HOSPITAL PRECINCT 2016 FUTURE TRAFFIC FLOWS

Appendix A - Stakeholder Submissions

**SYDNEY ADVENTIST HOSPITAL SITE, WAHROONGA REDEVELOPMENT
(MAJOR PROJECT 07_0166) – DIRECTOR GENERAL'S ENVIRONMENTAL ASSESSMENT
REQUIREMENTS**

EXISTING/FUTURE COMENARRA PARKWAY/FOX VALLEY ROAD CONFIGURATION

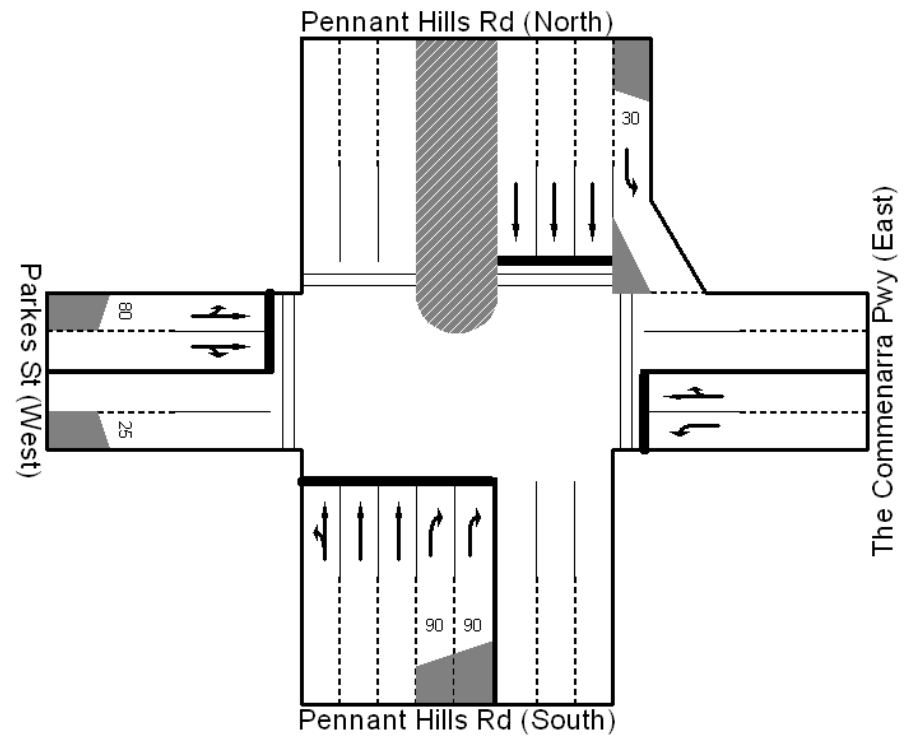
This would allow significant capacity to be added by providing two lanes in each direction in The Comenarra Parkway between the eastern boundary of the land owned by the hospital and Browns Road in the west.

The recommended intersection configuration is shown in **Figure D-2**.

EXISTING/FUTURE FOX VALLEY ROAD/PACIFIC HIGHWAY CONFIGURATION

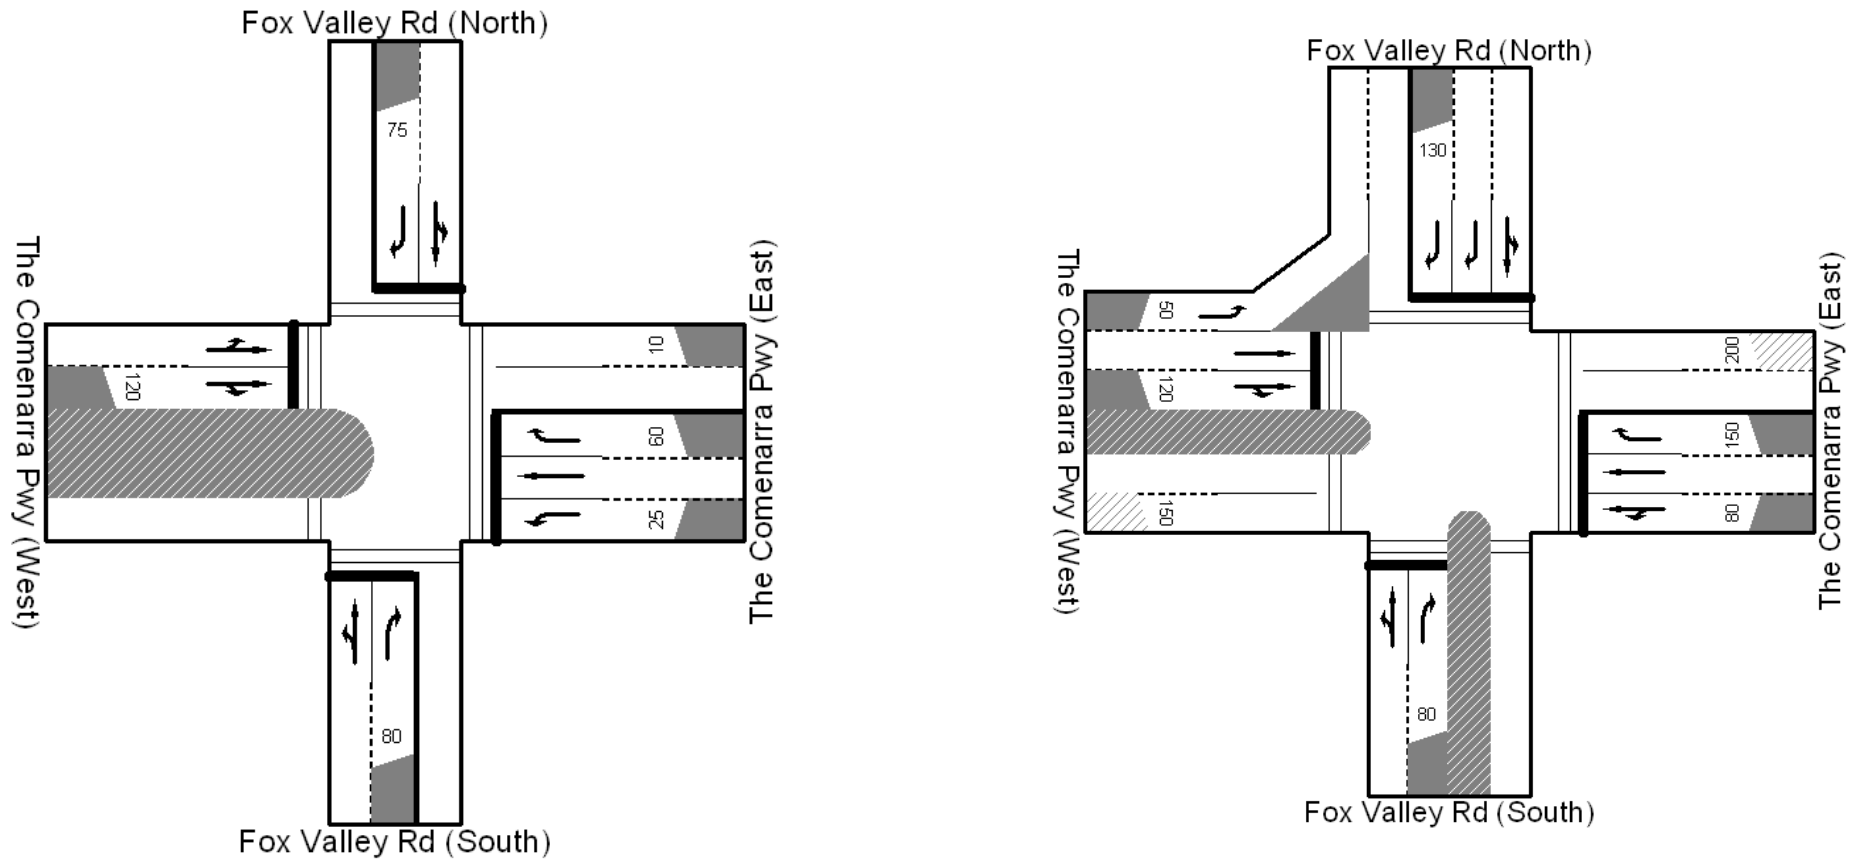
A third right turn bay from Fox Valley Road into Pacific Highway southbound would provide more queuing space for vehicles turning right into Pacific Highway. This in turn would enable more traffic throughput and reduce overall intersection delay.

It is also recommended that the right turn bay from Pacific Highway southbound be extended to 160m to provide additional queuing space.

These changes are shown in **Figure D-3**.

PENNANT HILLS ROAD/OSBORN ROAD

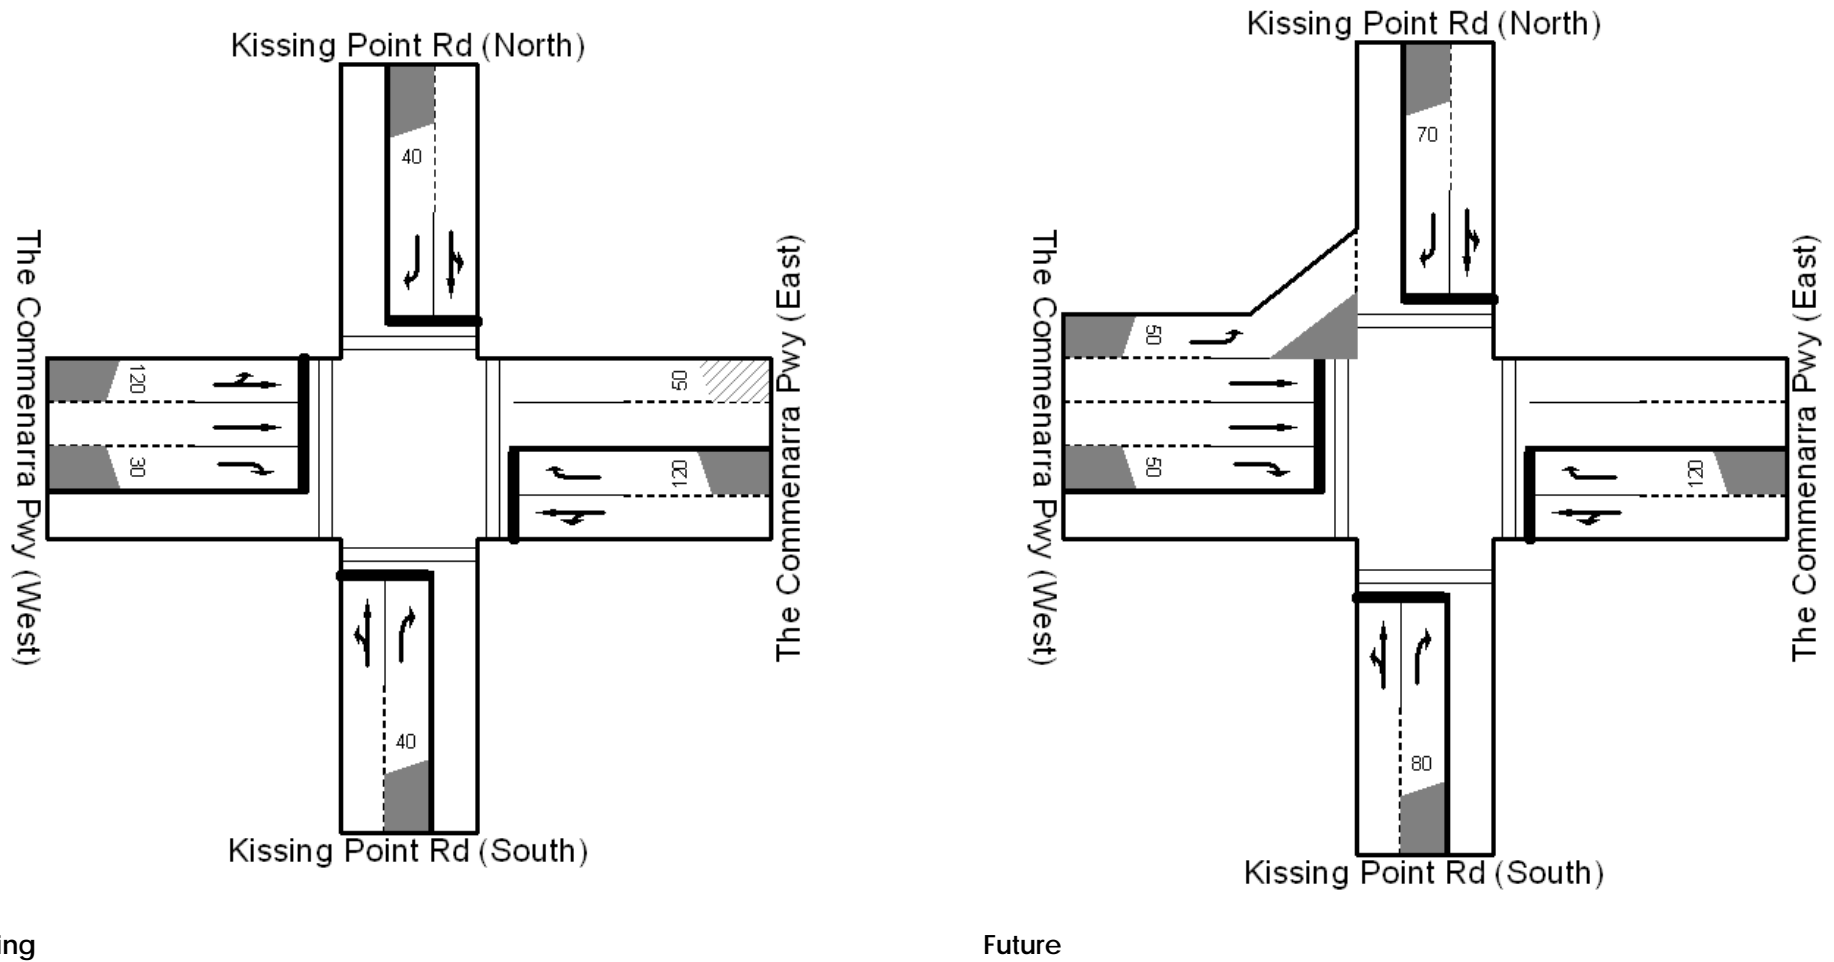
As stated in Section 2, traffic turning out of Mt Pleasant Avenue currently experiences delays. In addition, the right turn movement out of Mt Pleasant Avenue is considered dangerous, requiring vehicles to cross three lanes of approaching traffic before entering the northbound stream.

It is suggested the difficult right turn movement out of Mt Pleasant Avenue would be banned once the road connection is made.

The proposal to connect Osborn Road to Mt Pleasant Avenue in the south would enable existing and future residents' access to a traffic signal controlled intersection for right turns in and right turns out. This will markedly improve the safety for these residents.

The road connection and future road network is shown in **Figure D-5**.
